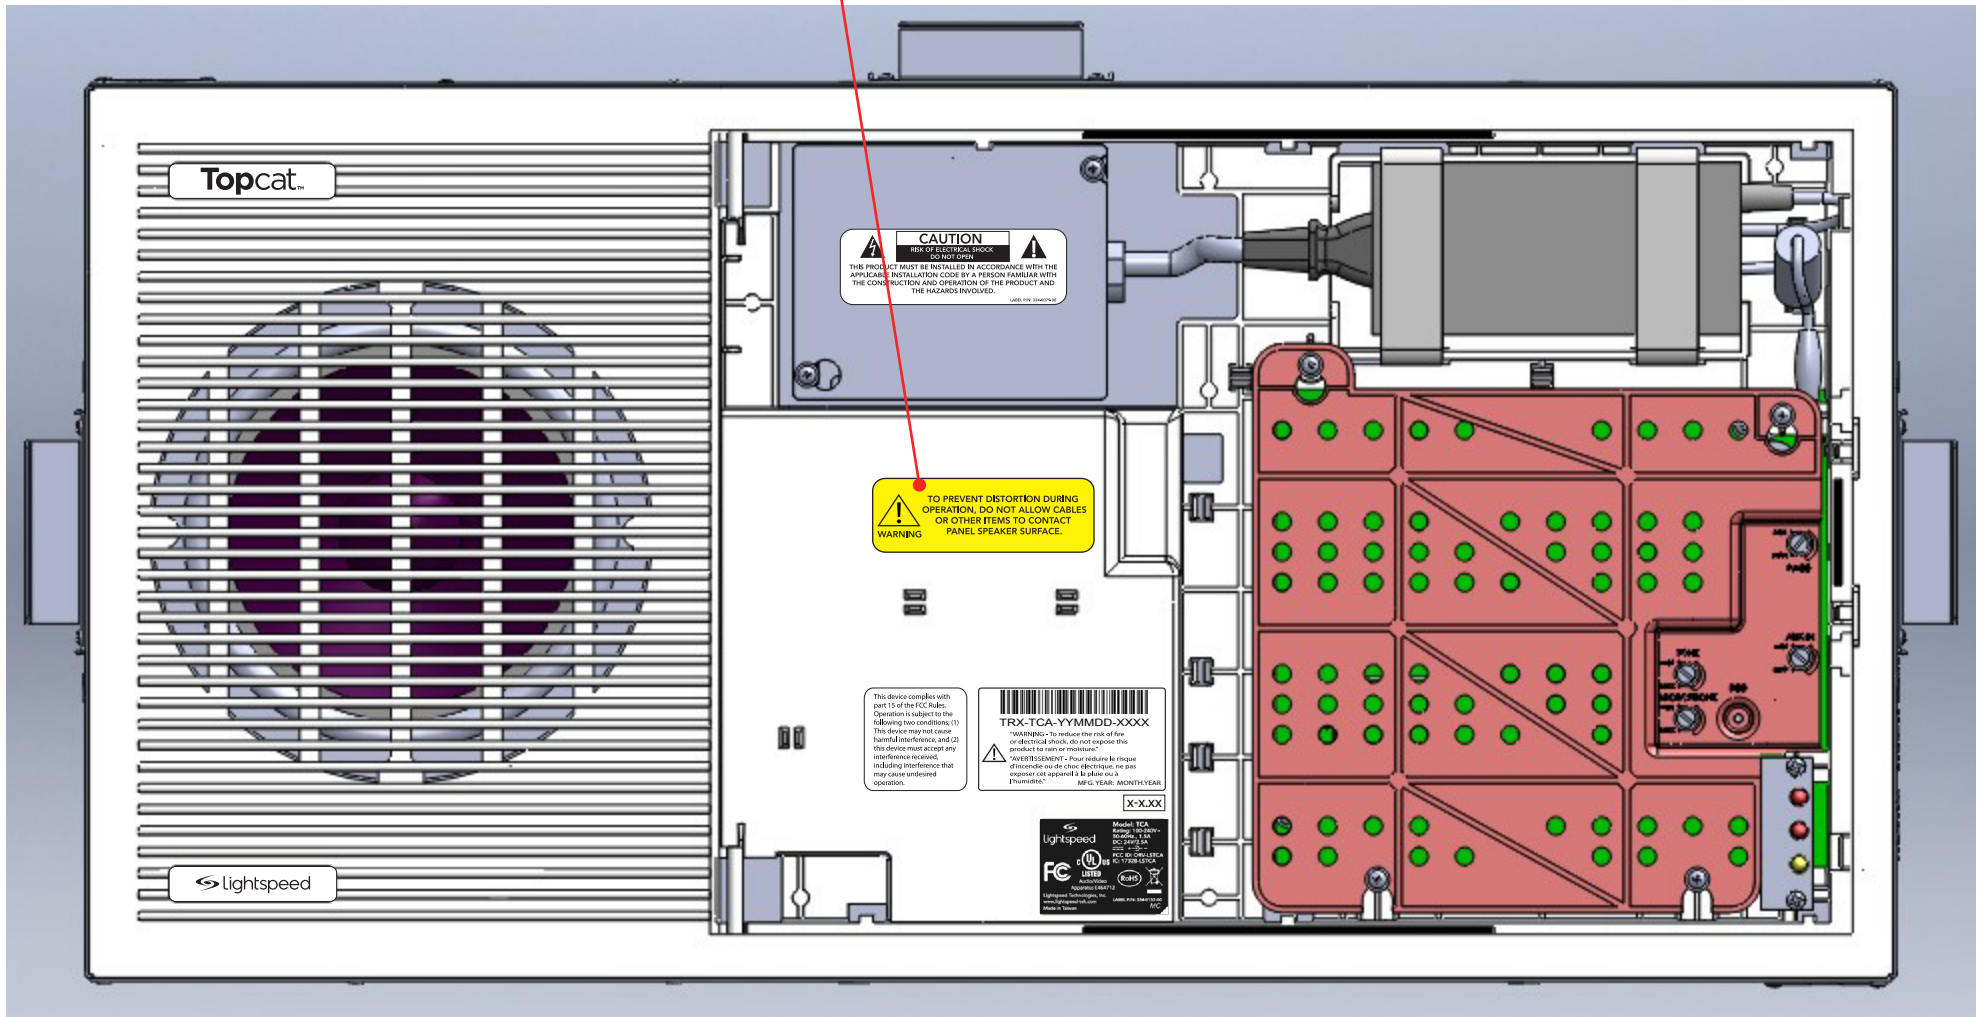
THE CABLE INSTALL LABEL (YELLOW) SHOULD BE NEAR THE WIRING FOR THE NXT PANEL.
WE'VE FOUND THAT INSTALLERS NEED TO ENSURE THE WIRE DOES NOT TOUCH THE PANEL.
LOCATING IT ANYWHERE ELSE BUT BESIDE THE WIRING WOULD DEFEAT THE PURPOSE.

THE NAMEPLATE ALREADY HAS A CUTOUT INSIDE - WE SHOULD USE IT.
THE SERIAL NUMBER AND SW REVISION LABEL SHOULD BE PLACED ABOVE THE NAMEPLATE.
THE FCC PART 15 (FOR PRODUCTION ONLY - NOT PILOT) SHOULD BE PLACED IN THE AREA.
